Ducted Systems Technical Services: Service Tips Letter

Letter: ST-003-22

Subject: **P266 Factory Installed Low Ambient Controller Parameter Change**

Product/s: Pro (Series 10) 3-12.5 Ton Packaged Equipment

Alternate High Voltage wiring:

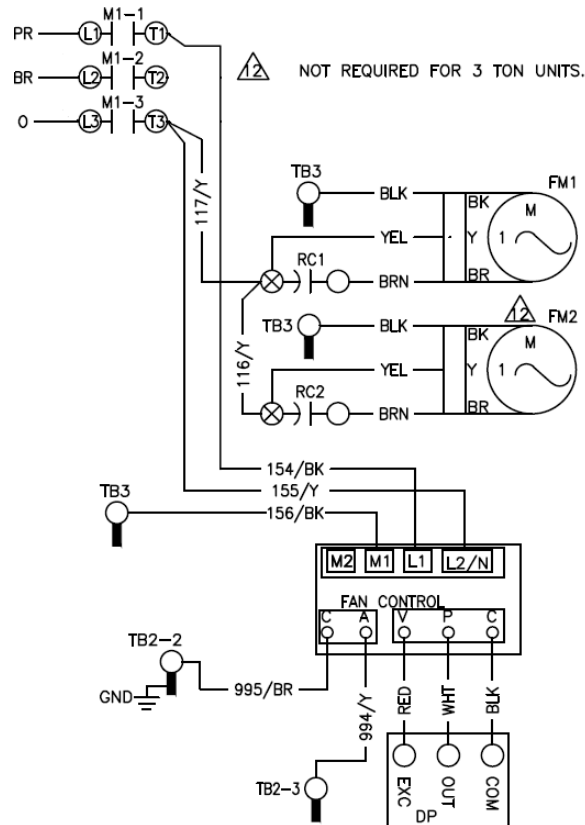
Note: Wiring numbers and colors may differ between nomenclature types, wiring should be as follows:

- T1 Wire —————> P266 L1
- T3 Wire —————> P266 L2/N
- FM 1 and 2 L1 wire —————> P266 M1
